ARCOM # A-24-0072

Siegfried Residence
127 El Bravo Way
Palm Beach, FL

Previously Approved Hardscape Plan

Proposed Hardscape Plan

4
H2.1
PROPOSED SETBACK LANDSCAPE
OPEN SPACE DIAGRAM
SCALE: 1/16" = 1' 0"

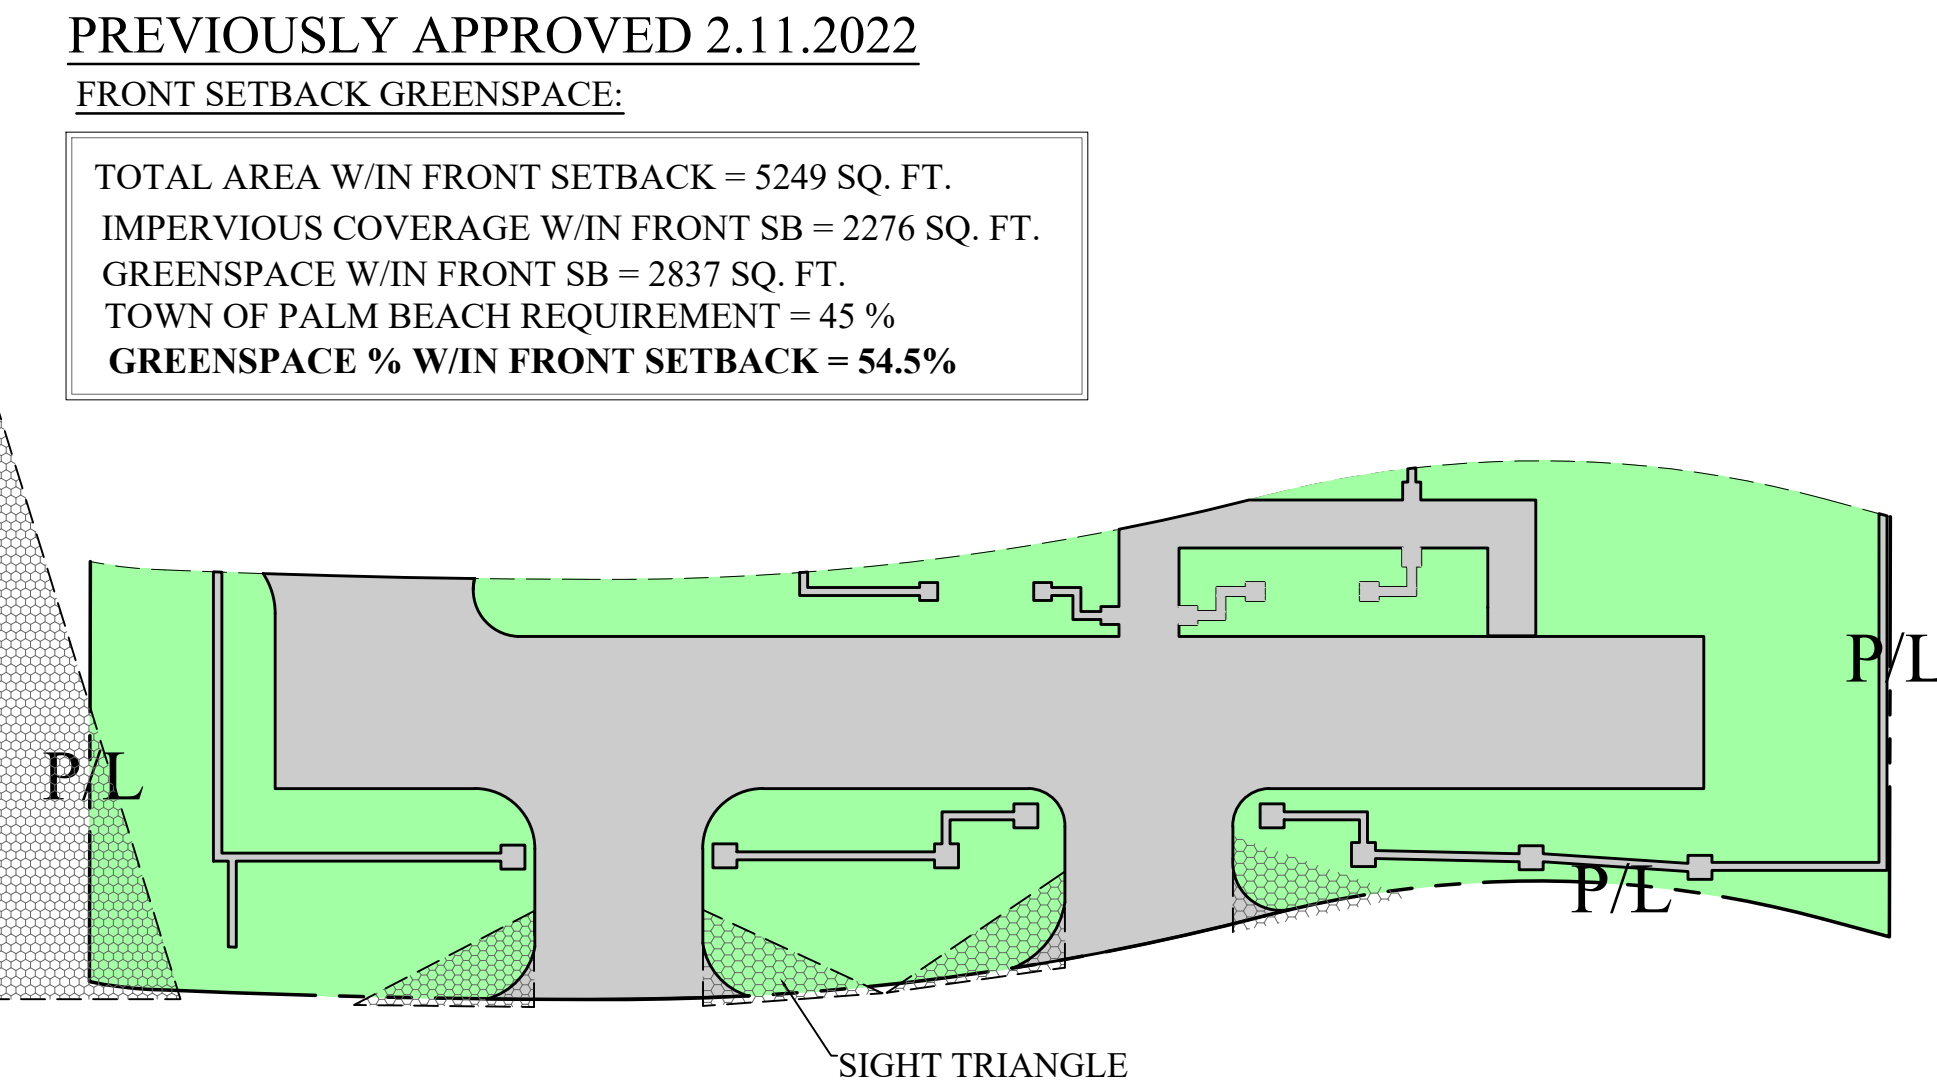
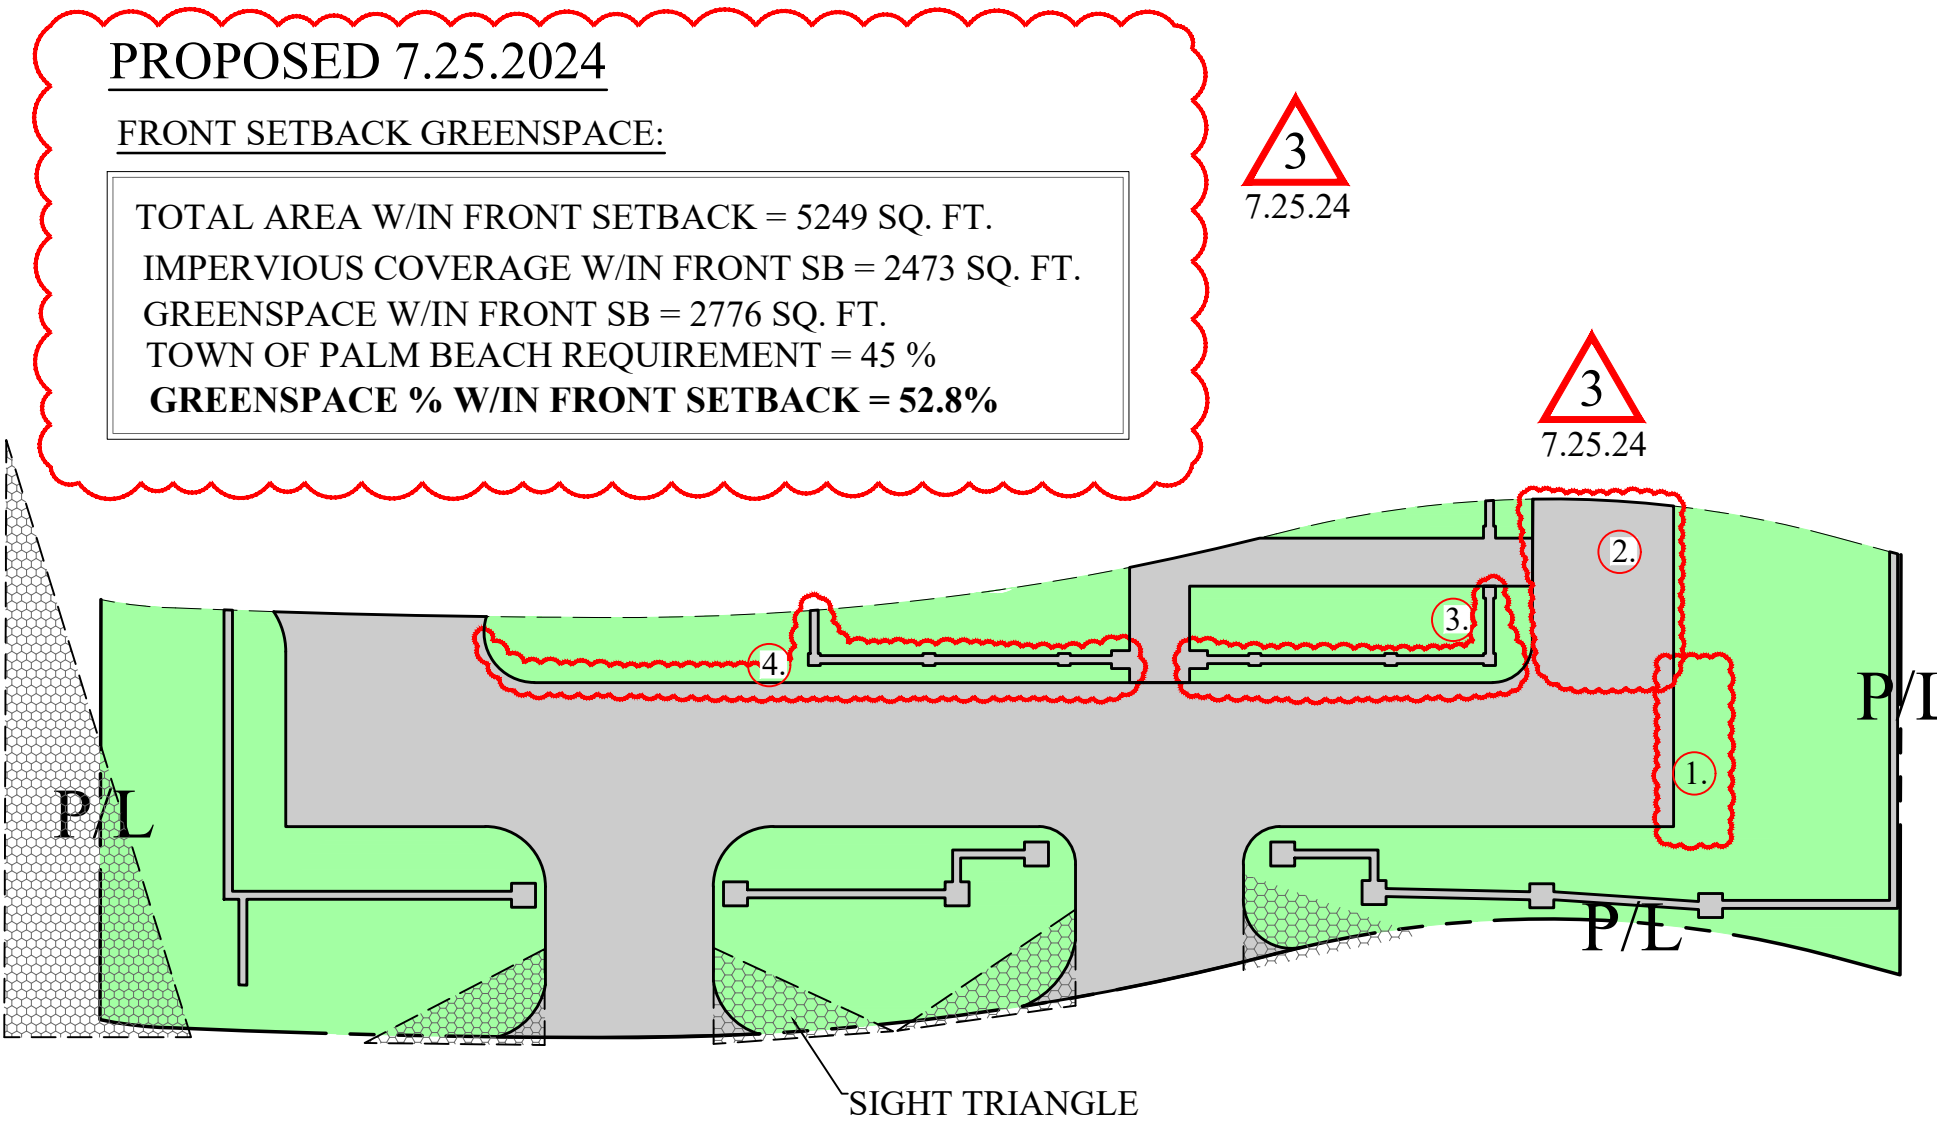
1. REDUCE LENGTH OF DRIVE 3' 5"
2. ADD SMALL PARKING SPACE
3. MOVE GARDEN WALL & GATES
4. NARROW DRIVE 9"
5. EXTEND WALK TO LOGGIA
6. ENLARGE PLANTING PITS
7. REDUCE POOL TERRACE

1
H3
PROPOSED COURTYARD WALL &
COLUMN ELEVATION
SCALE: 1/2" = 1' 0"

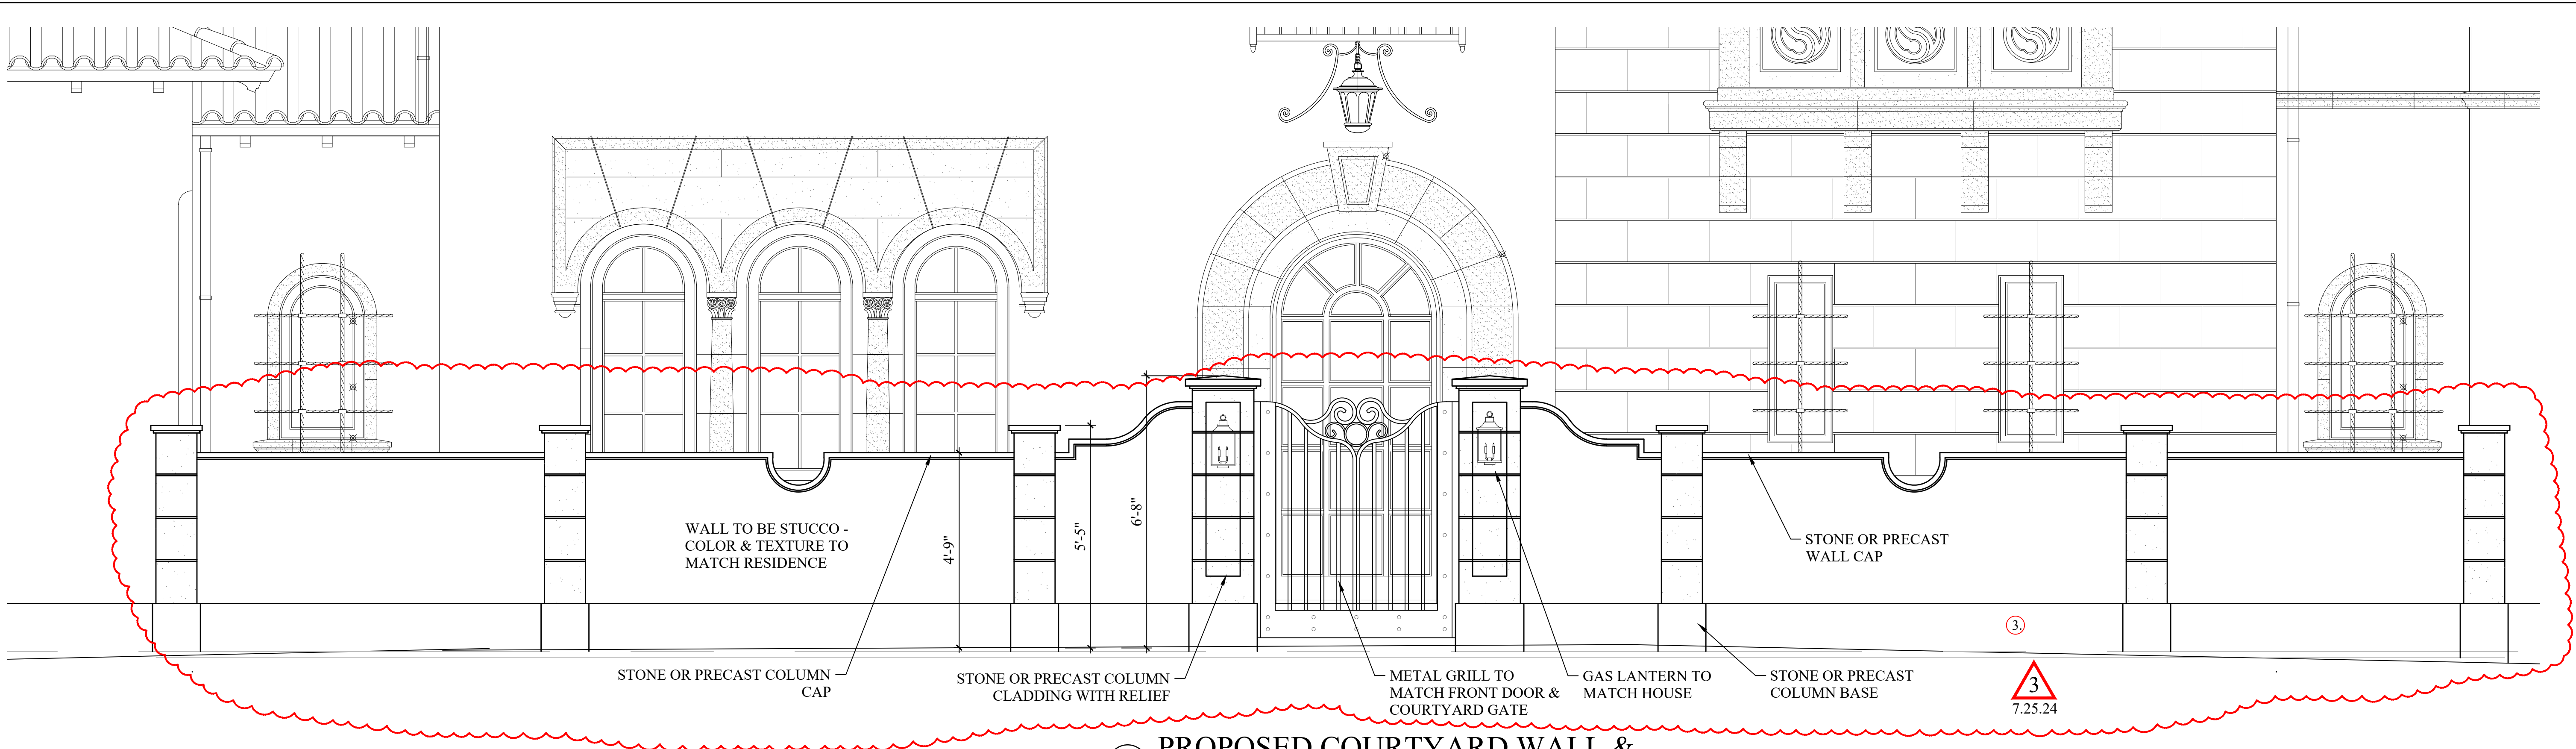
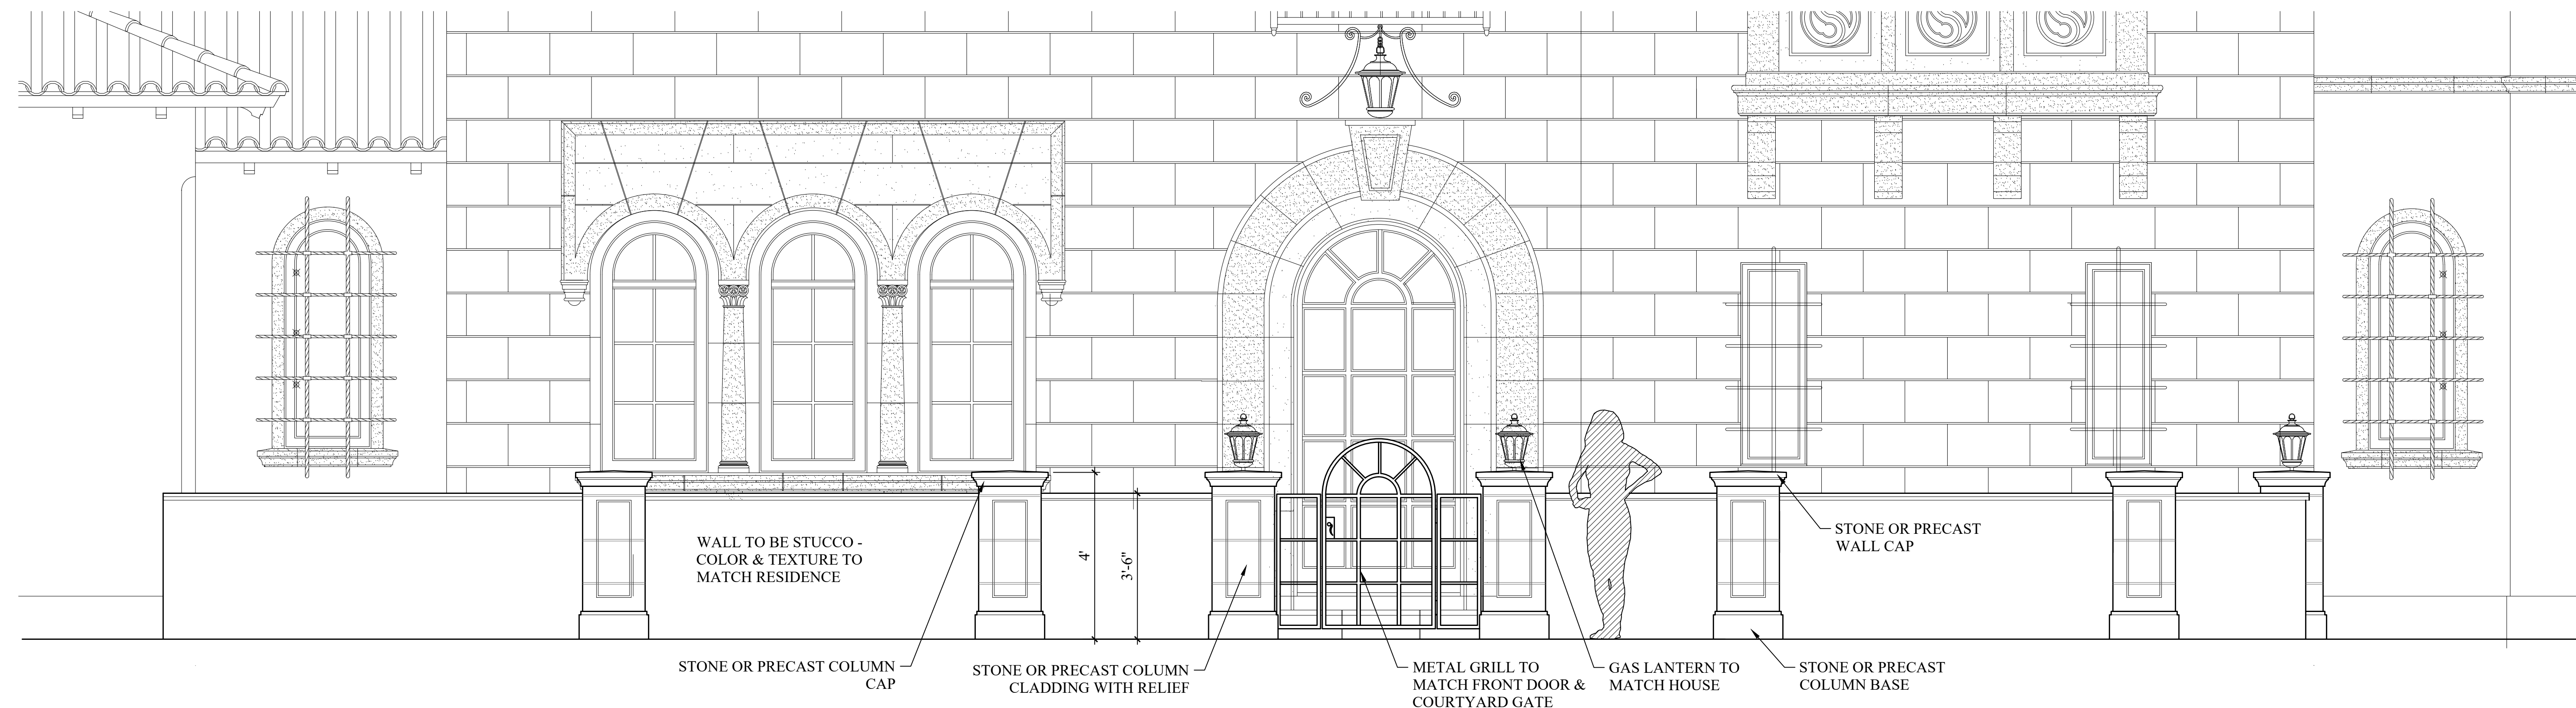
CHANGE LOG
NUMBERS FOR THIS SHEET ONLY
3. MOVE GARDEN WALL & GATES

NOTE:
HEIGHT OF WALL SHALL NOT EXCEED SIX FEET ABOVE THE
CROWN OF THE STREET AT A POINT DIRECTLY OPPOSITE
SUCH POINTS OF MEASUREMENT
GATEPOSTS & GATES SHALL NOT EXCEED A HEIGHT OF TWO
FEET ABOVE THE MAXIMUM WALL HEIGHT PERMITTED
